STATE OF OHIO DEPARTMENT OF TRANSPORTATION

OTT-2-23.29

RESURFACE SR-2 AND 2-C IN OTTAWA COUNTY; WORK WILL INCLUDE STRUCTURE WORK AND NECESSARY RELATED WORK.
STRUCTURES INCLUDE: OTT-2-2725 AND OTT-2-2757

SHEET ADDED
(pbq #10)
60-85, 62A
86-100

STANDARD CONSTRUCTION DRAWING **MC-9**

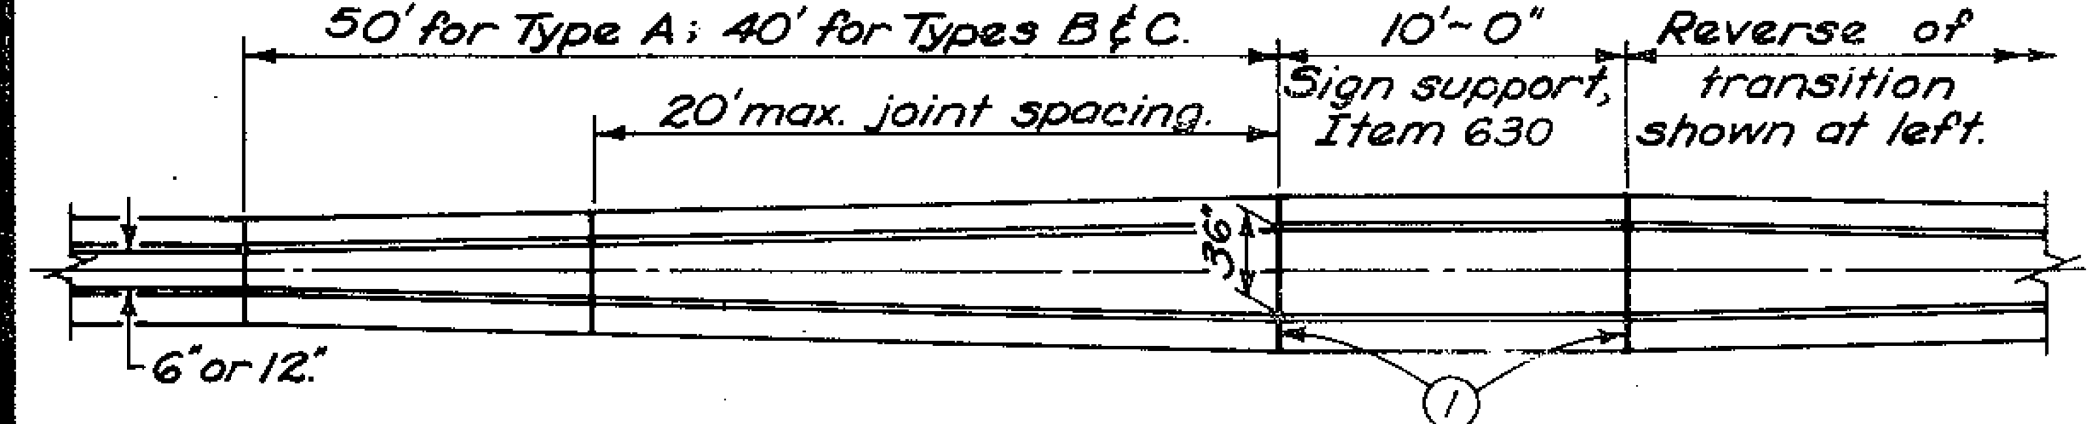
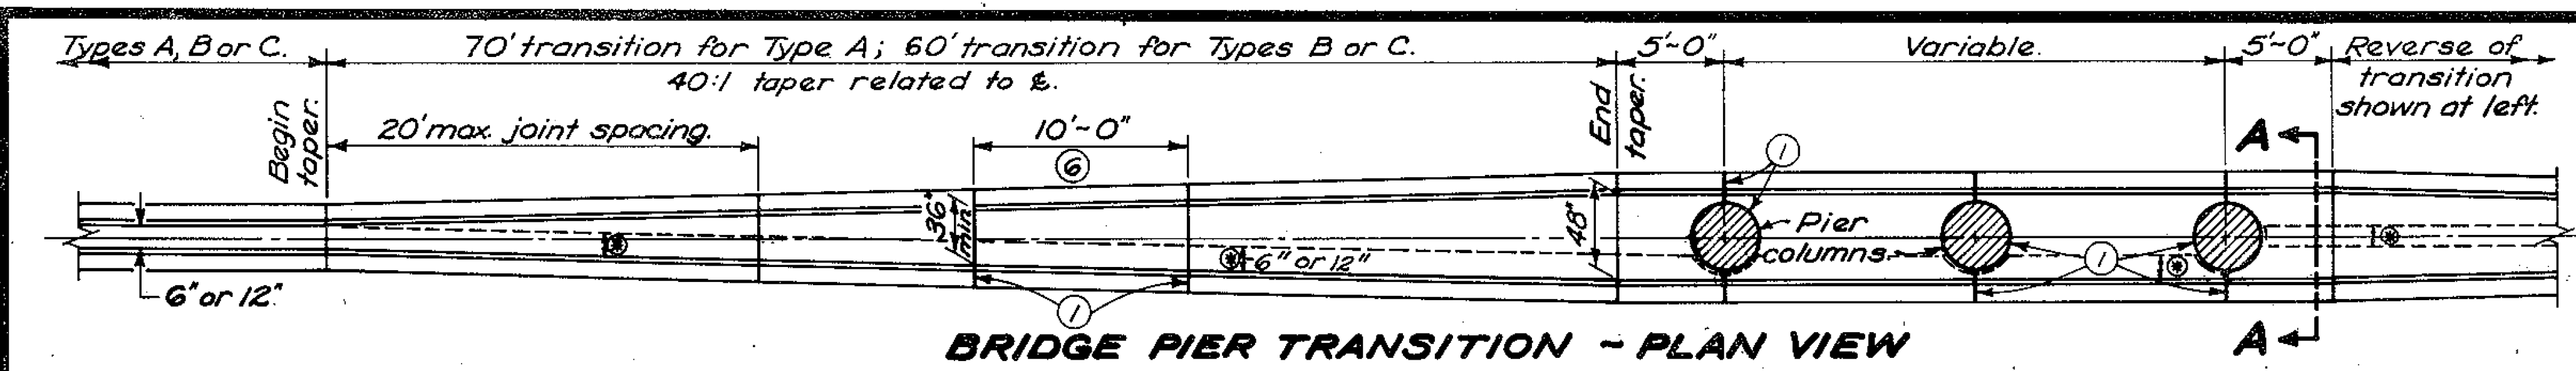
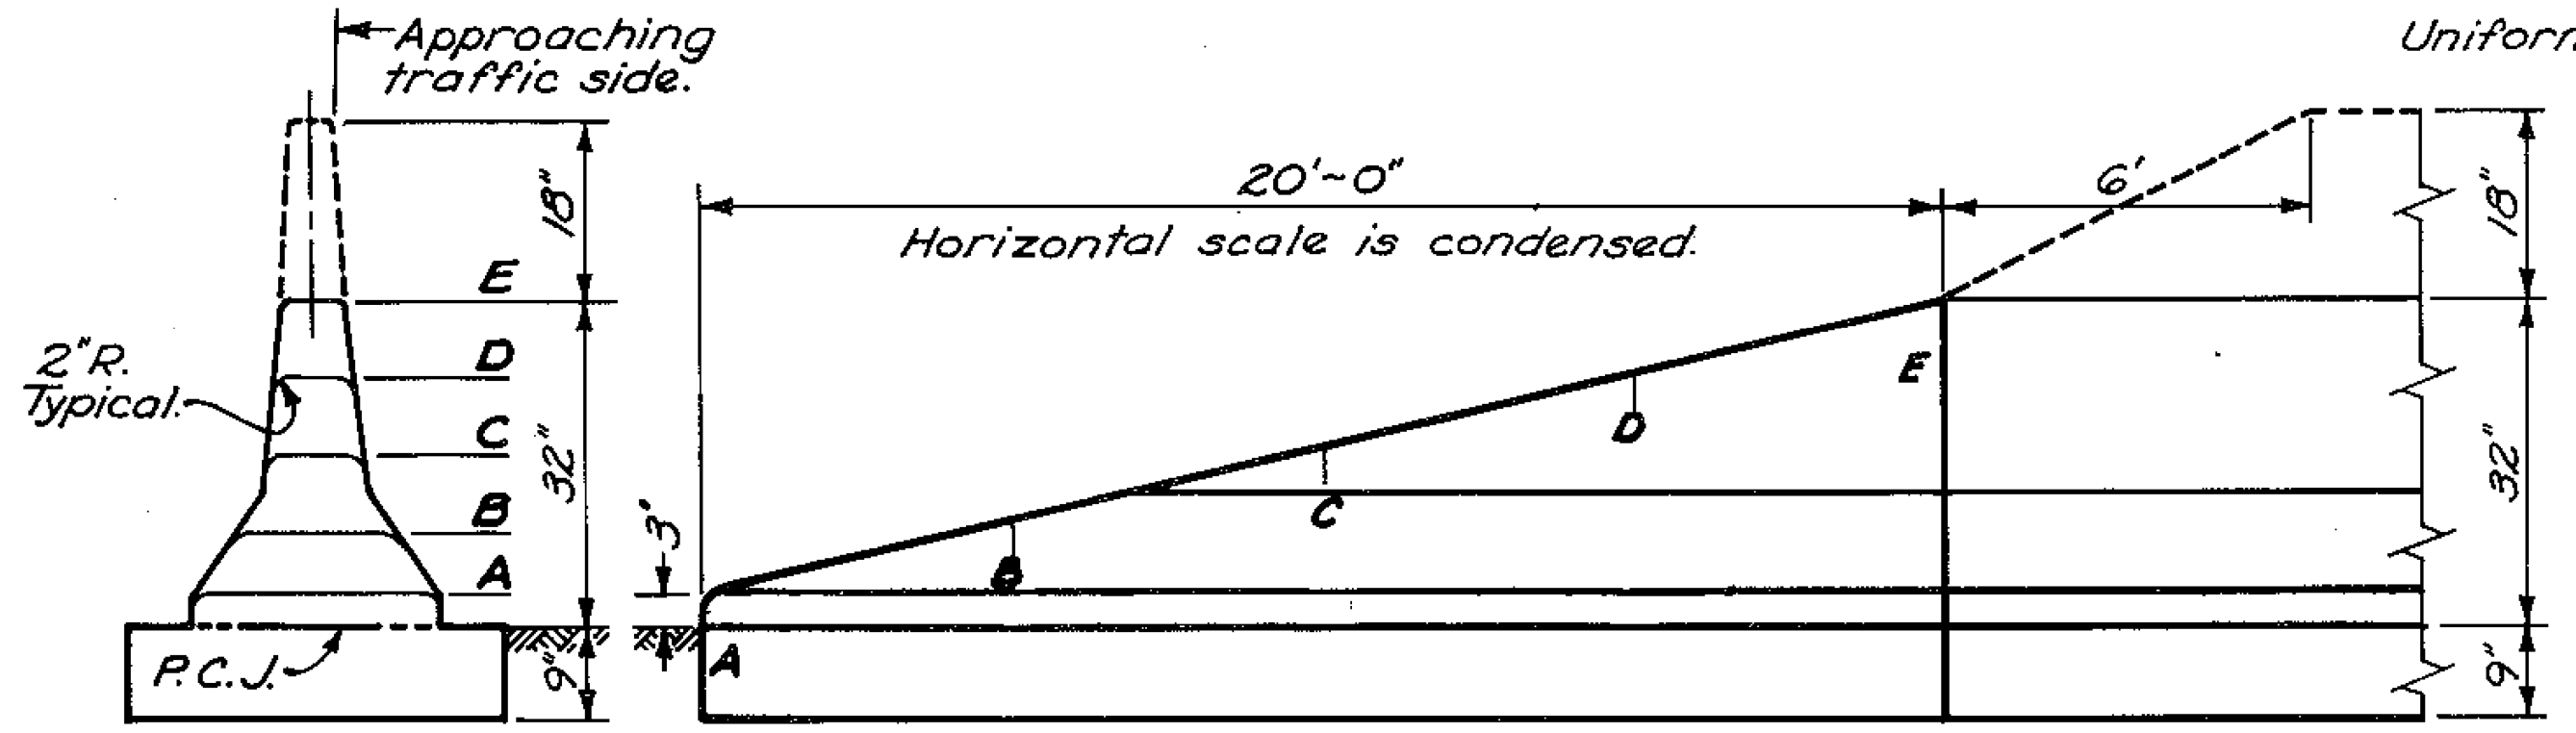
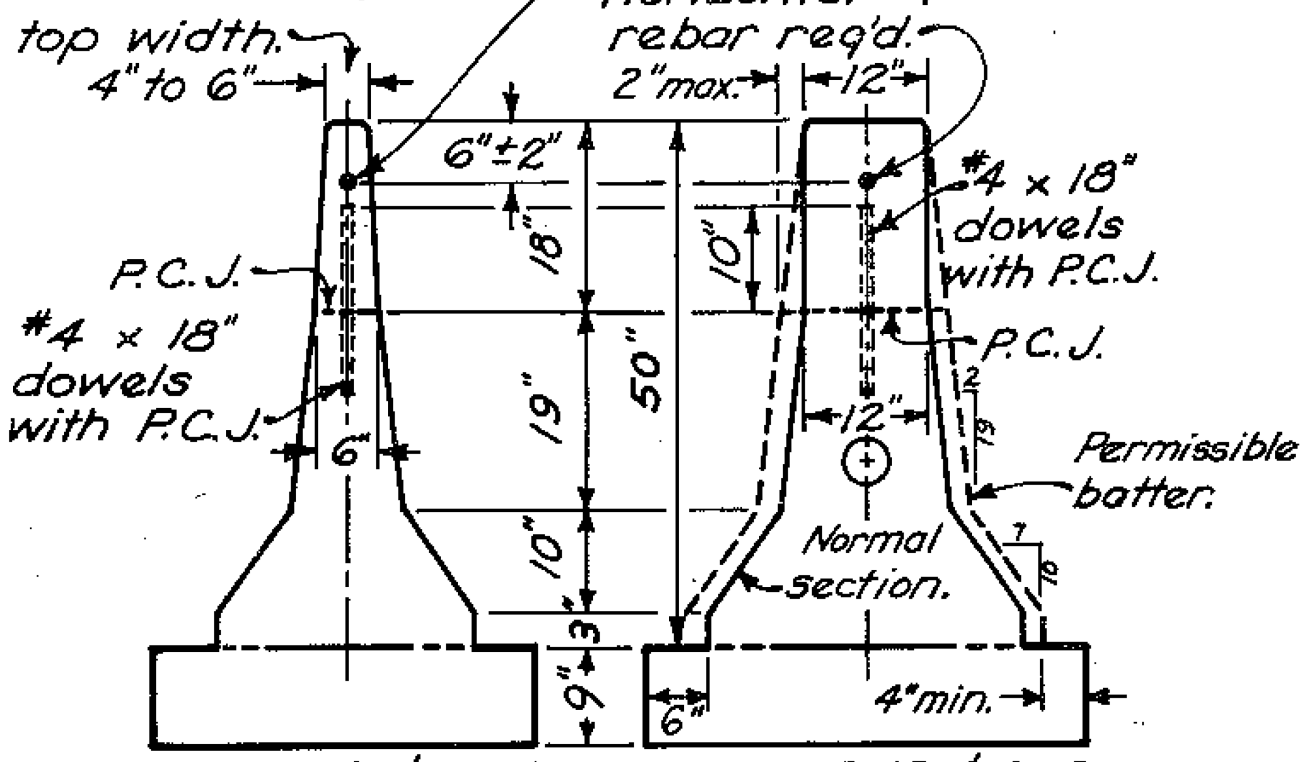
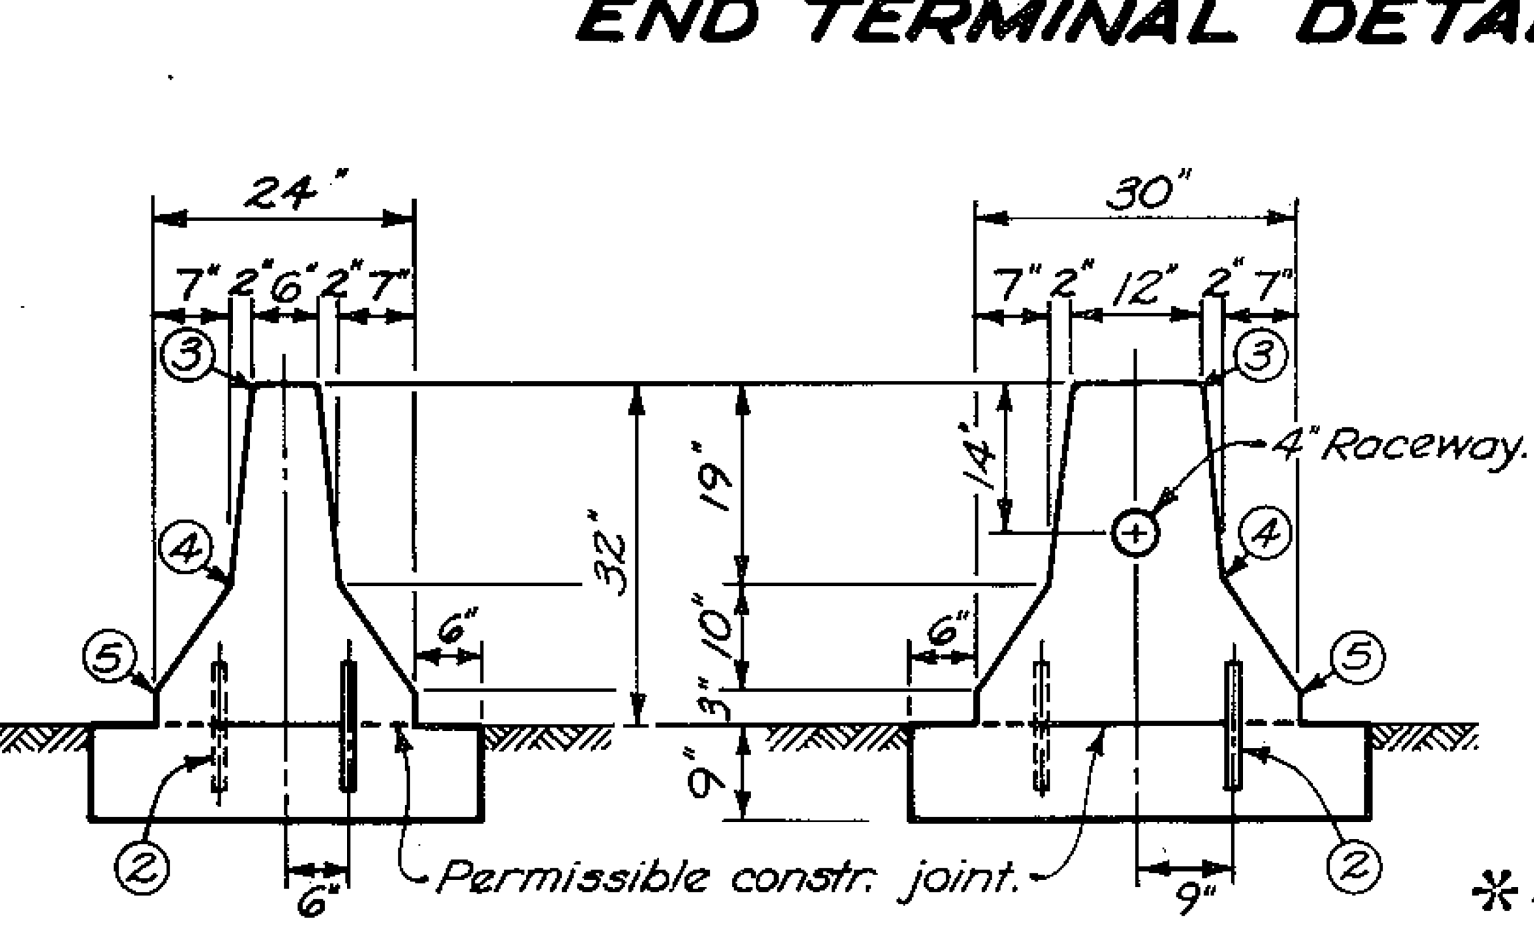
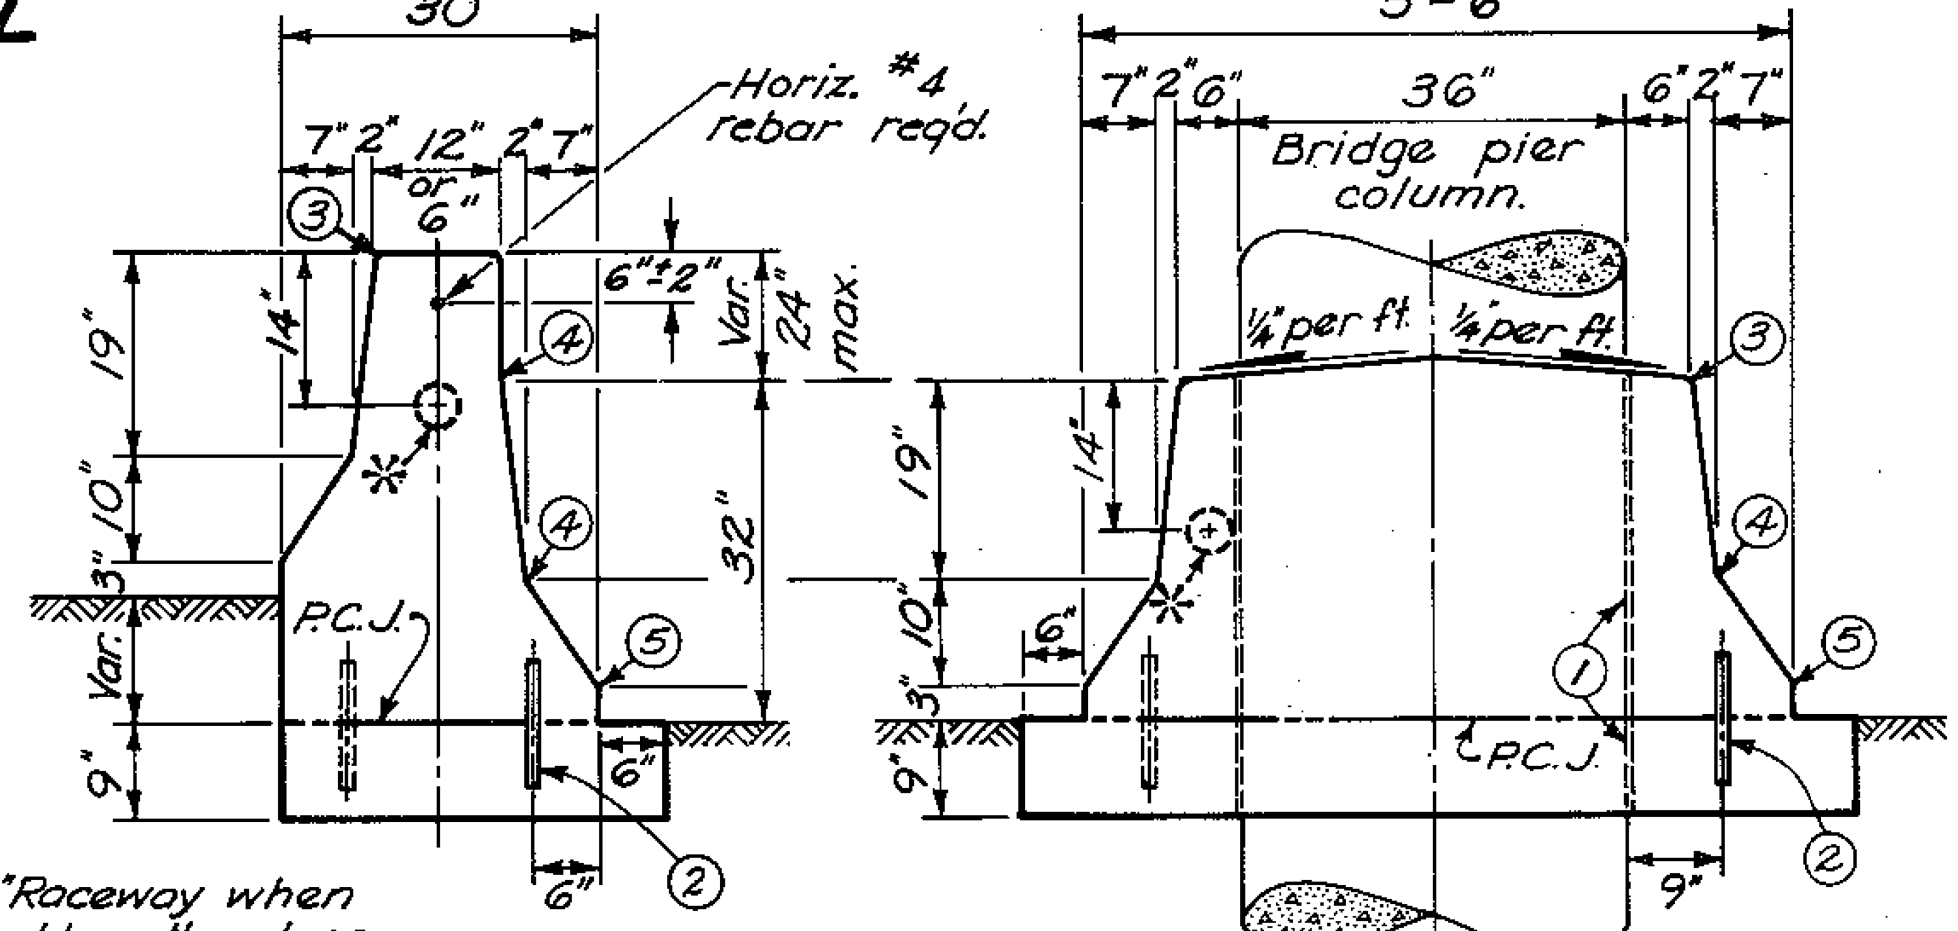
SHEET ADDED (PBQ #10)

ITEM 622 - BARRIER, MISC.: 50" HIGH BARRIER (MC-9)

THIS WORK CONSISTS OF CONSTRUCTING PORTLAND CEMENT CONCRETE BARRIER ON THE ACCEPTED AND PREPARED SUBGRADE PER C&MS ITEM 622 CONCRETE BARRIER. THE DIMENSIONS AND DETAILS FOR THIS BARRIER SHALL CONFORM TO THOSE SHOWN FOR 50" HIGH BARRIER TYPE A50 IN THE RETIRED OHIO DEPARTMENT OF TRANSPORTATION STD. DWG. MC-9 DATED 1-30-1984.

ITEM ADDED (PBQ #10)
